[FR Doc No: 2019-14307]

[Docket No. FAA-2019-0469; Product Identifier 2019-CE-028-AD; Amendment 39-19664; AD 2019-12-09]

Airworthiness Directives; Rockwell Collins, Inc. Flight Display System Application

ACTION: Final rule; request for comments.

Figure 1 to paragraph (g)(3) of this AD; placard location on bezel

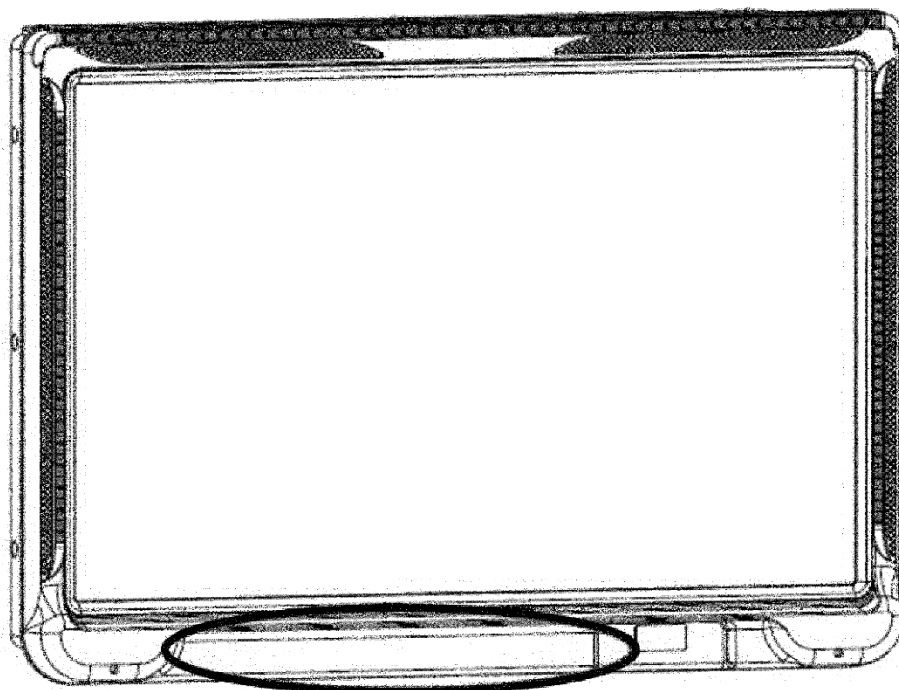
(2) Fabricate a placard for each aircraft primary flight display, using at least 1/8 inch letters, with the following text: TCAS Flight Ops–TA Only mode (TA/RA mode prohibited).

(3) Install the placard on the bottom of each aircraft primary flight display bezel in the area depicted in figure 1 to paragraph (g)(3) of this AD.
